215-B-002  
 UNUM Correspondence  
 re new building  
 1997-1999

Project: UNUM HO3  
 Prepared by: Charles P. Urnek  
 Re: Preliminary Code Review  
 Distribution: Attendees, TC, JGS, WLD, RMC, EC (MF)

Re: HO3 Office Building

**Re: UNUM Parking Garage  
Code Issues  
Project No: 16-1170.00**

Symmes Maini & McKee Associates Cambridge, MA	UNUM LIFE INSURANCE HO-3 PORTLAND, MAINE	DATE	9/23/98	SKE 43	
		SCALE	1/8" = 1'-0"		
REFERENCE DWG. FE2.4 ROOF PLAN		DR. BY	MZ	CK. BY	JOB NO. 97094.00

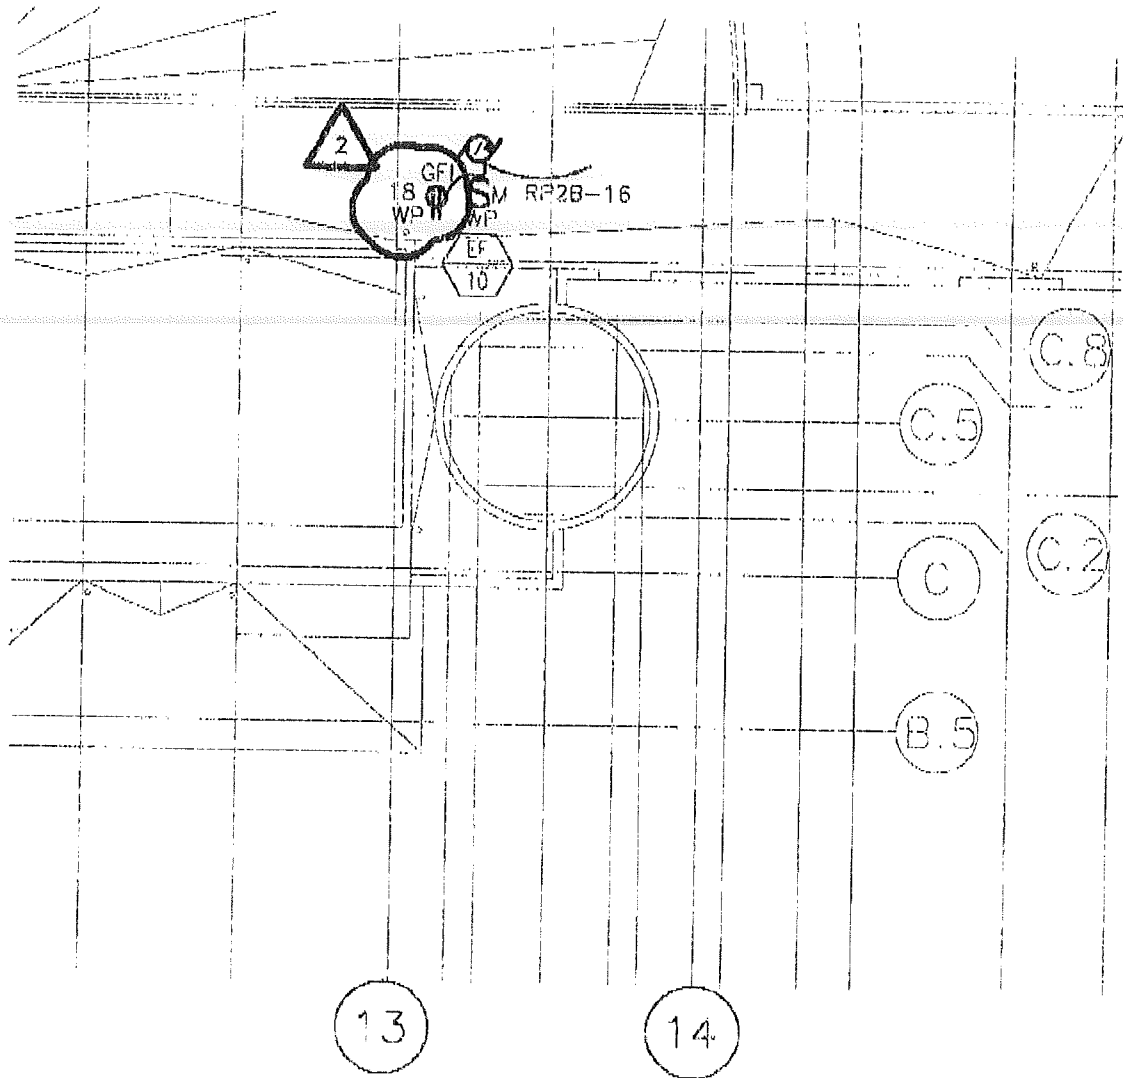
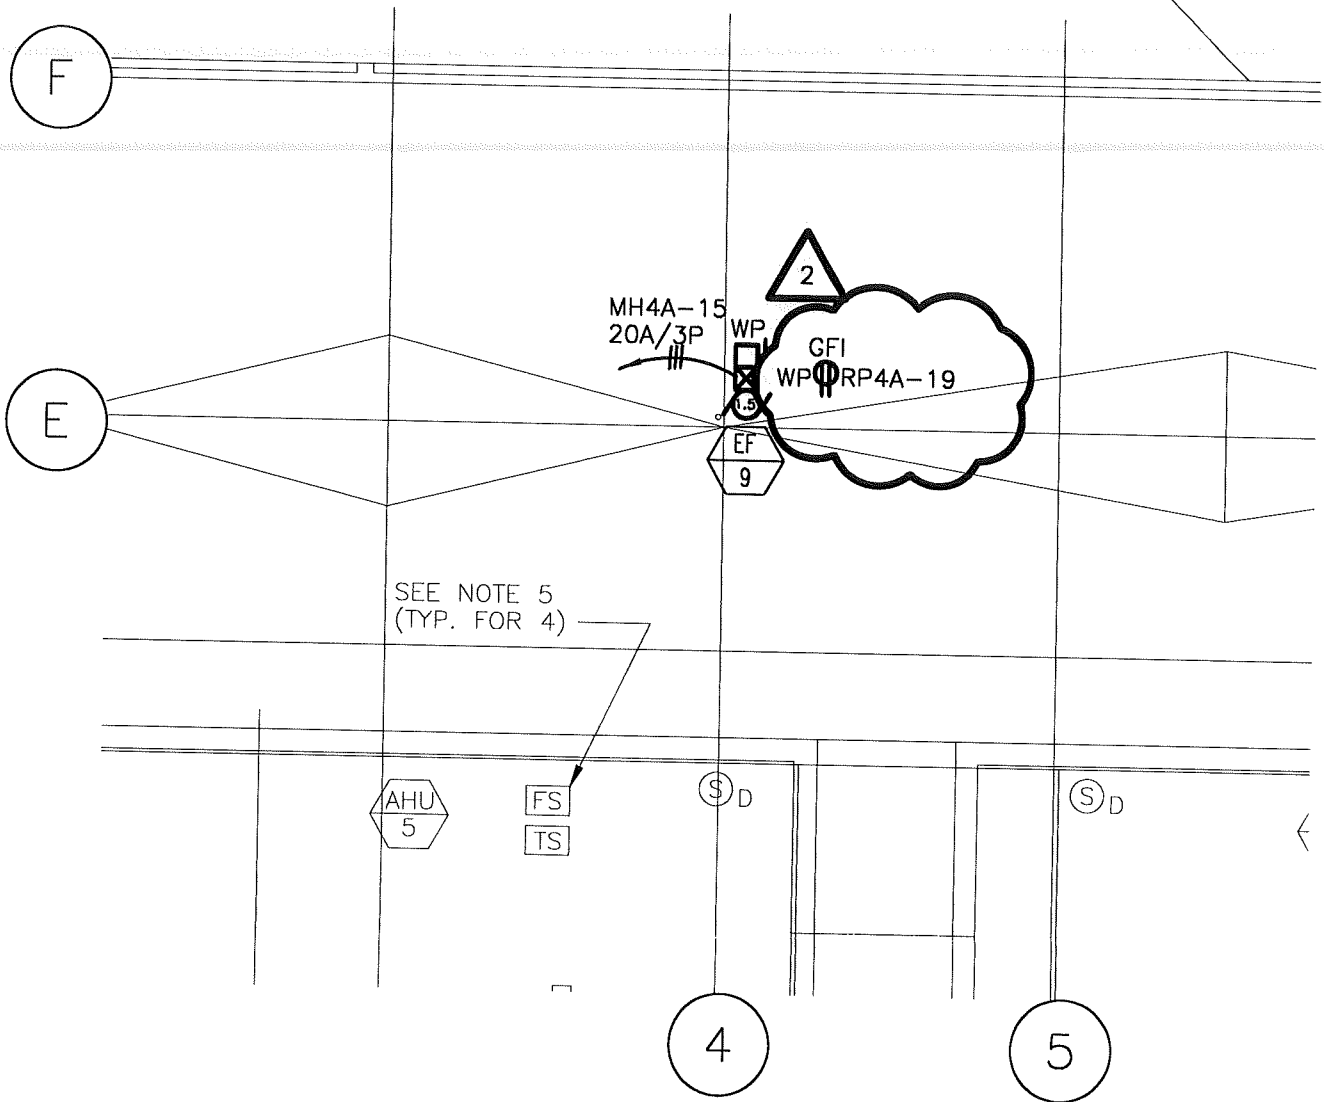
- Add a GFCI WP receptacle @ EF #9, located on the roof.
- Add a GFCI WP receptacle @ EF #10, located on the roof.

1. Ground fault type receptacles will be provided on the roof at the exhaust fans EF-9 and EF-10. Electrical plan will be revised per attached sketches SKE43 and SKE44, dated 9/23/98.
2. Article 410-76(b) of National Electrical Code, 1996 edition does not apply to the surface mounted fluorescent fixtures installed on the gypsum board type ceiling.

DETAIL OF GARAGE DECK DRAIN

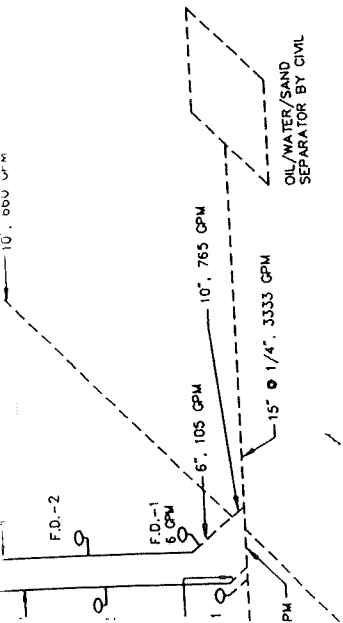
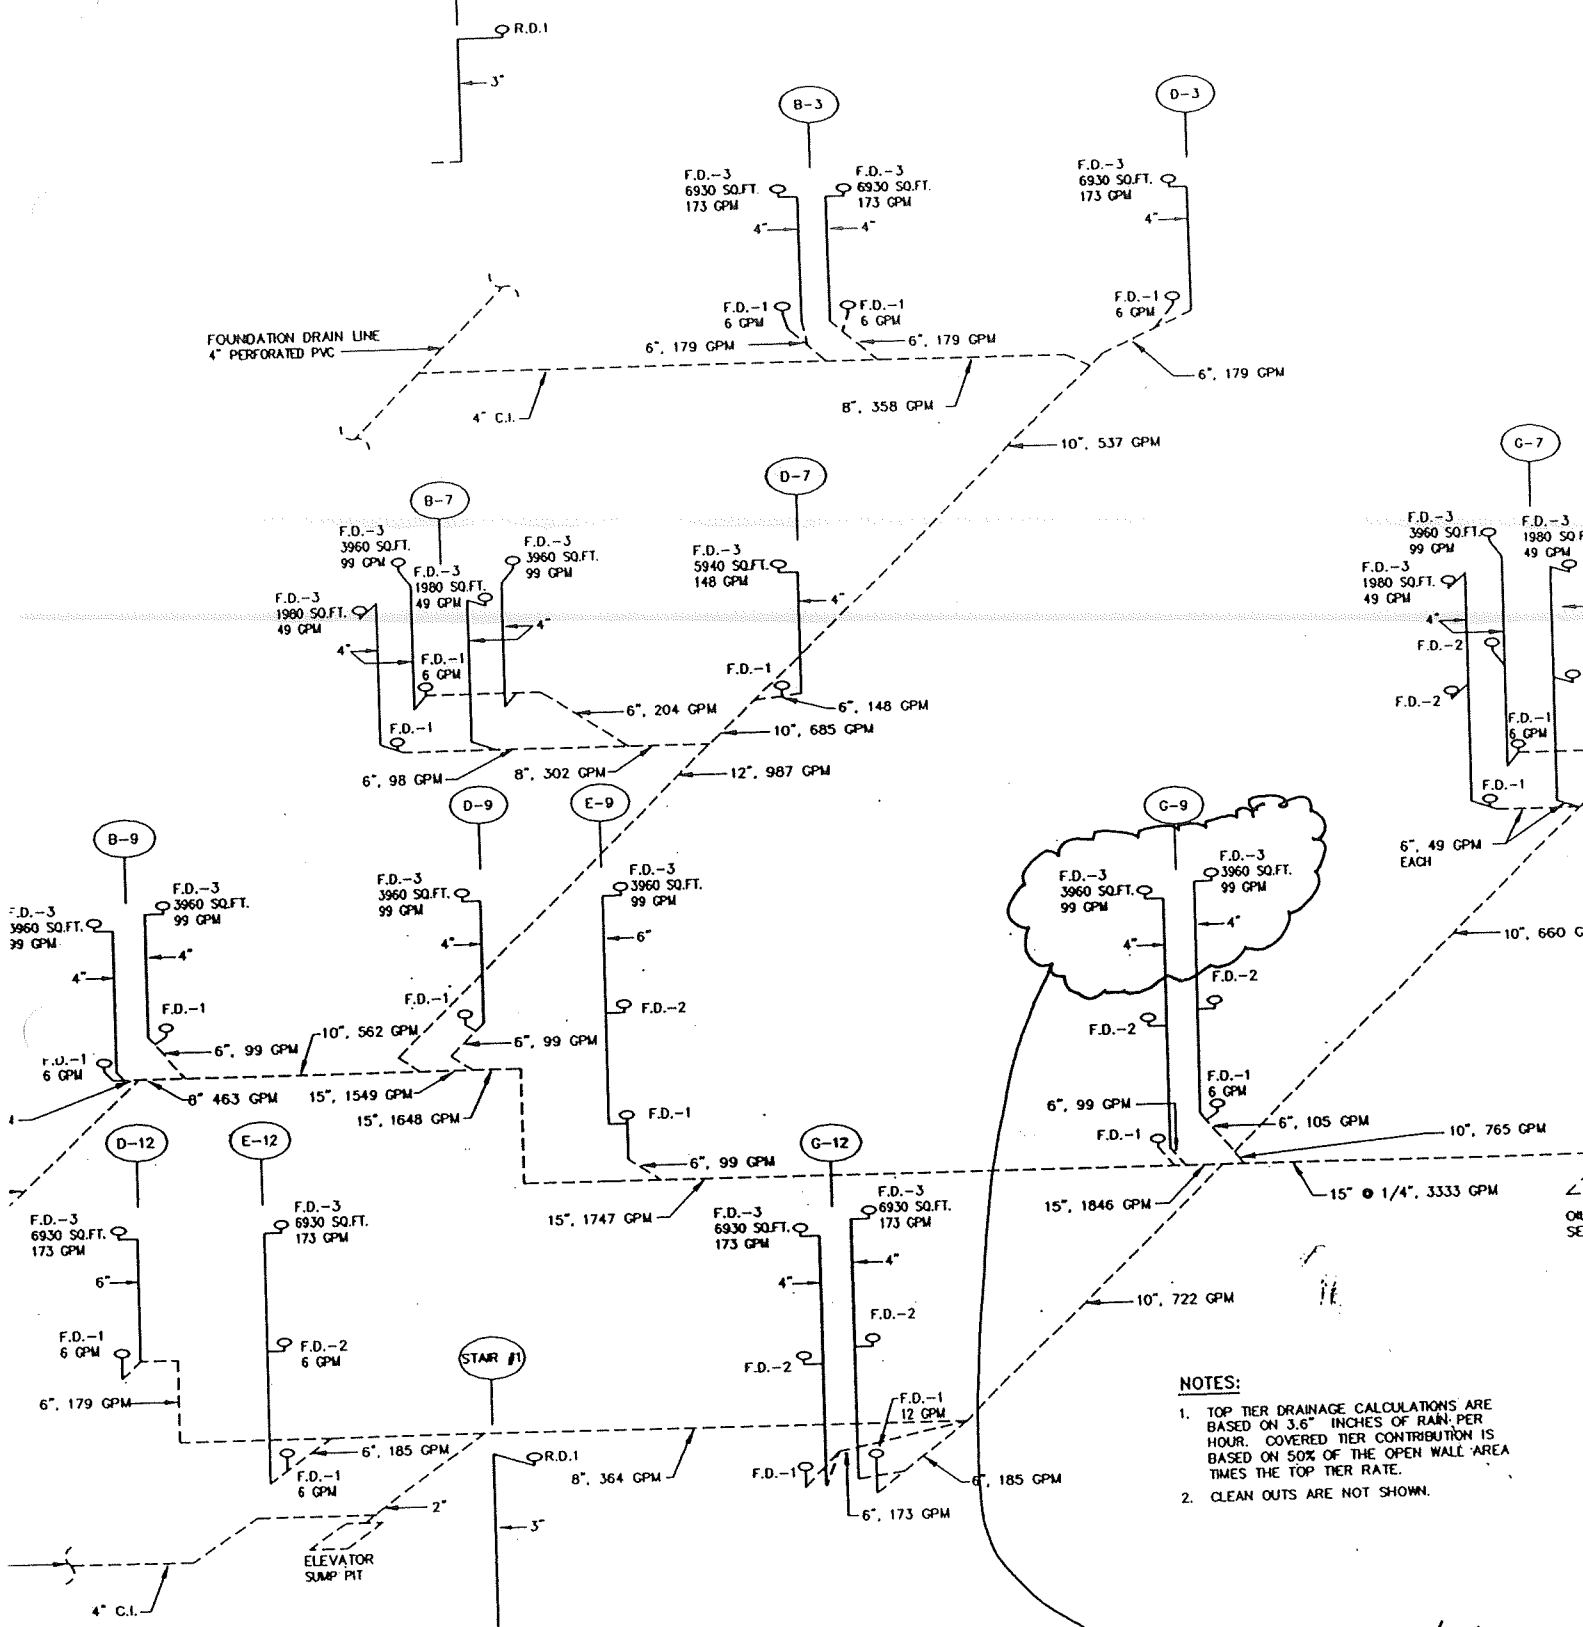
DRAINAGE RISER DIAGRAM SHOWS 4" RISERS

Walker has reviewed the attached plumbing detail, specifically the size reduction of the 6" drain line into a 4" riser. We find this detail acceptable as shown. If you have any questions, please call.

HOLLOW METAL ELEVATION - TYPE #2

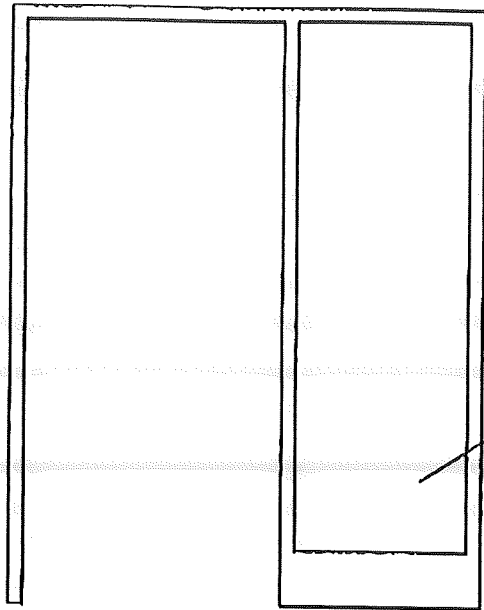
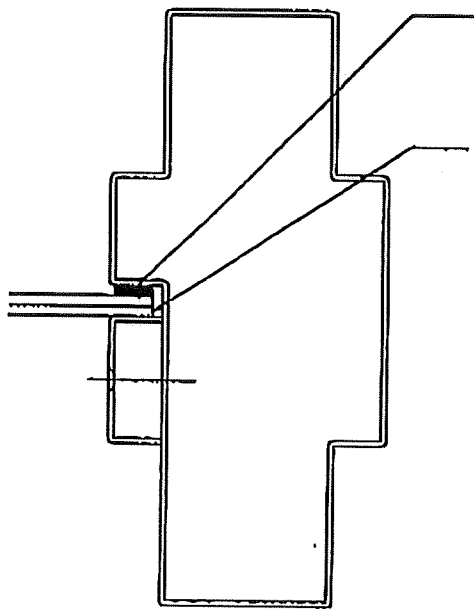
1/8" NORTON NORSEAL V740 FOAM TAPE AS REQD.  
 ARCHITECT PLEASE ADVISE COLOR, GREY OR BLACK

# PRESENTATION ROOM CORRIDOR

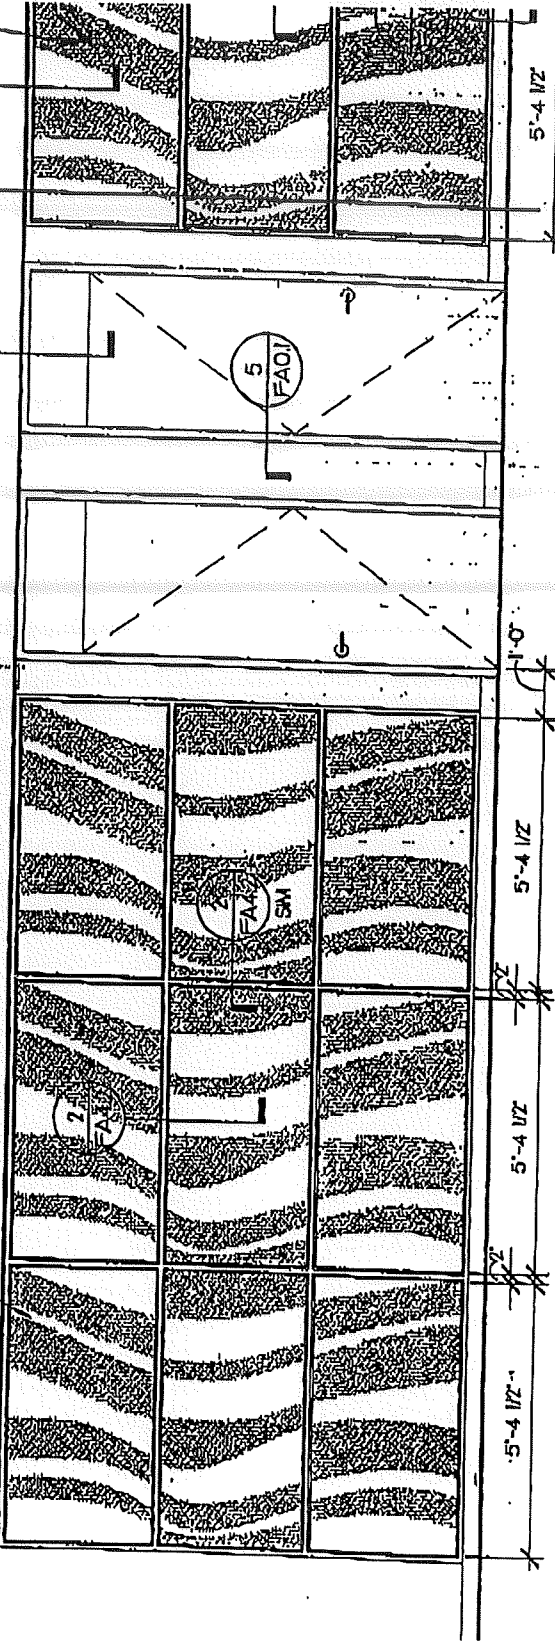
SIDEWIGHT  
 AT DOOR #101  
 SHOULD BE SIMILAR  
 TO THIS ONE
